Project 4040.027

Subject: **Tentative Waste Discharge Requirements**
Former Kendall Site, Merced, California

COMMENTS ON SPECIFIC SECTIONS OF TENTATIVE WASTE DISCHARGE REQUIREMENTS

14) ATTACHMENT C – FLOW SCHEMATIC

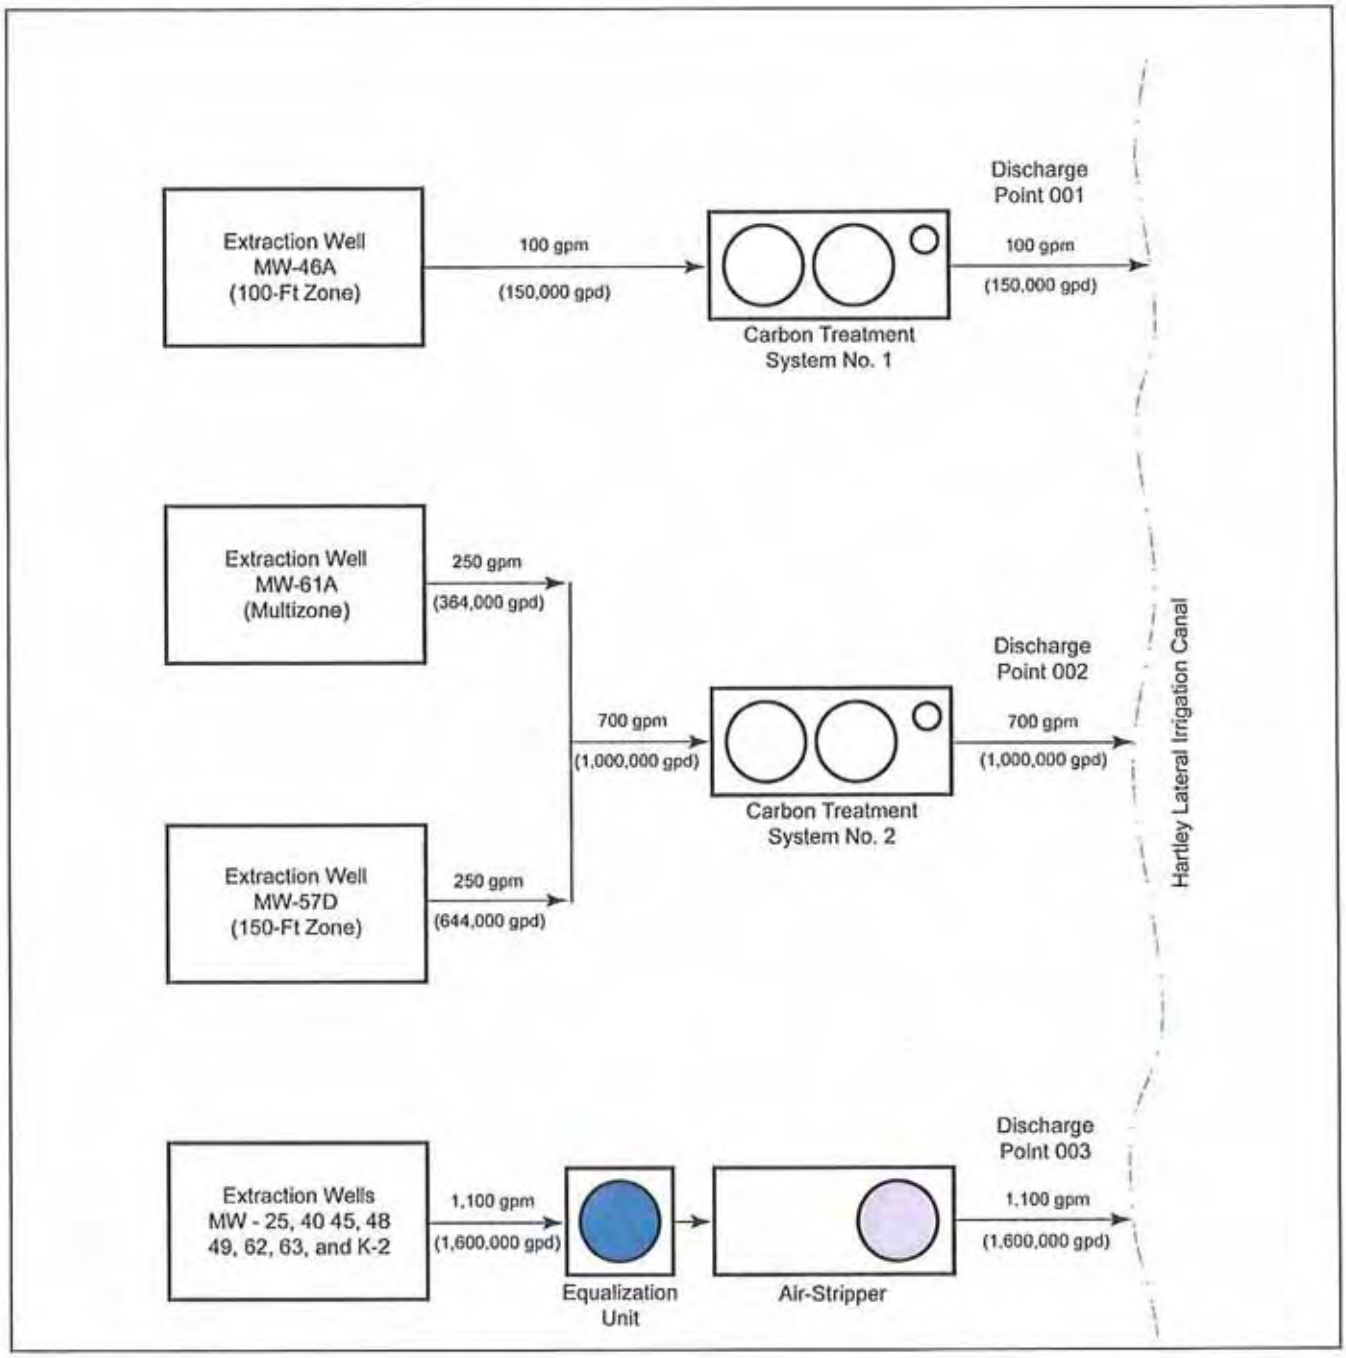
Attachment C is a flow schematic of the three treatment systems. The attachment should be updated to show well MW-44A as one of the air stripper extraction wells.
